MIL-N-60189(MU)
AMENDMENT 2
18 April 1967
SUPERSEDING
AMENDMENT 1
19 October 1966

MILITARY SPECIFICATION

NETWORK D CIRCUIT BOARD: 8623286

This amendment forms a part of Military Specification MIL-N-60189(MU), dated 23 February 1965.

FIGURE 2

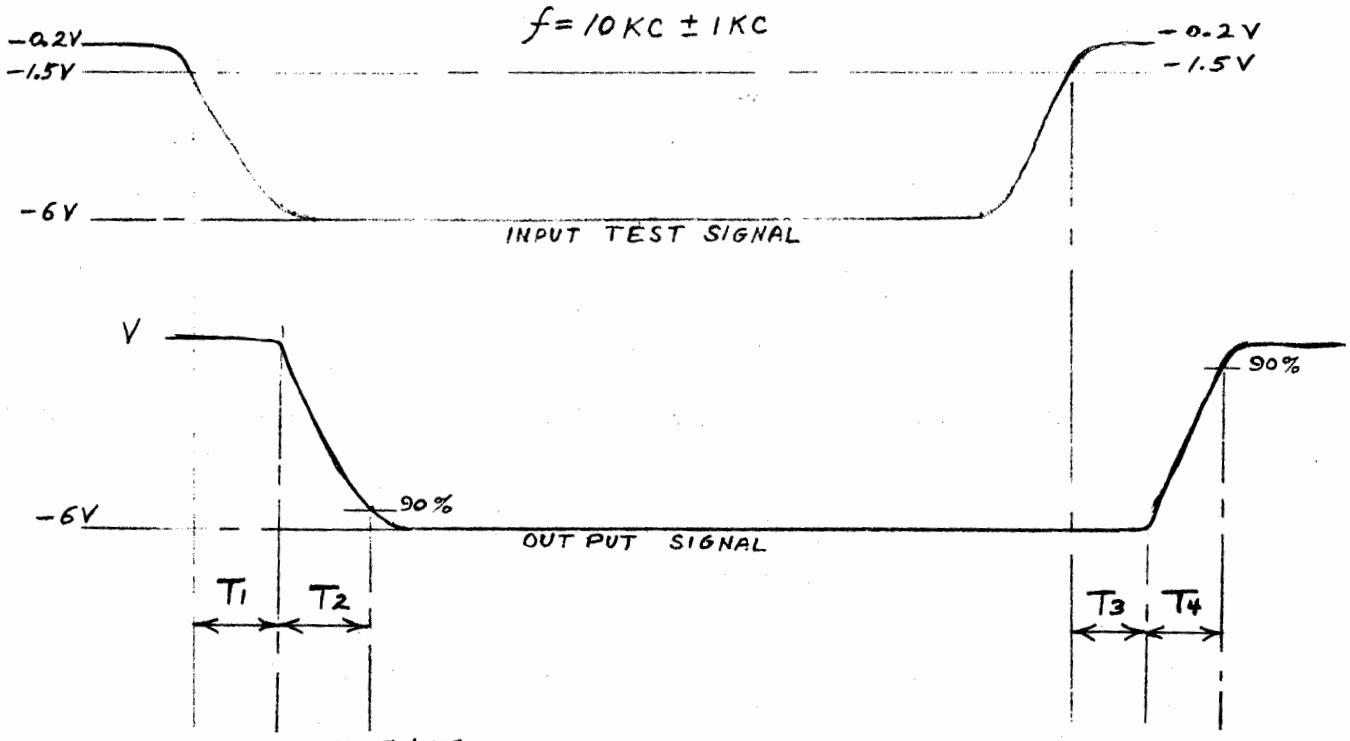
Figure 2: Delete and substitute new Figure 2 shown on Page 2 of this amendment.

CIRCUIT	OUTPUT VOLTS	$T_1 + T_2$ < 400 NANO. SEC.		$T_3 + T_4$ < 400 NANO. SEC.	
DUR. DLR.	+3 ± 0.12				
REGULAR	−0.15 ± 0.15	$T_1 + T_2$ < 400 NANO SEC.		$T_3 + T_4$ < 400 NANO SEC.	
		T_1	T_2	T_3	T_4
CLOCK	+6 ± 1.0	< 3 μ SEC.	< 1 μ SEC.	< 3 μ SEC.	< 500 NANO SEC.
CLOCK INHIBIT	+3 ± 0.12	< 5 μ SEC.	< 1 μ SEC.	< 5 μ SEC.	< 1 μ SEC.

Delay time comparison of input and output waveforms. The delay time (T_1 and T_2) from the time the square wave applied to the input gate reaches minus 1.5 volts (going towards minus 6 volts) until the output reaches 90% of its total excursion (going towards minus 6 volts) and delay time (T_3 and T_4) measured from the time the square wave applied to the input gate reaches minus 1.5 volts (going towards zero volts) until the output reaches 90% of its total excursion (going towards the false state plus 3 volts) shall be as indicated in the table. The delay time (T_1) is measured from the time the square wave is applied to the input gate reaches minus 1.5V (going toward -6V) until output just starts descending and the delay time T_3 is measured from the time the square wave applied reaches -1.5V (going toward zero volts) until the output just starts rising. For extreme temperatures add 5% to the limits of $T_1 + T_2$ and $T_3 + T_4$.
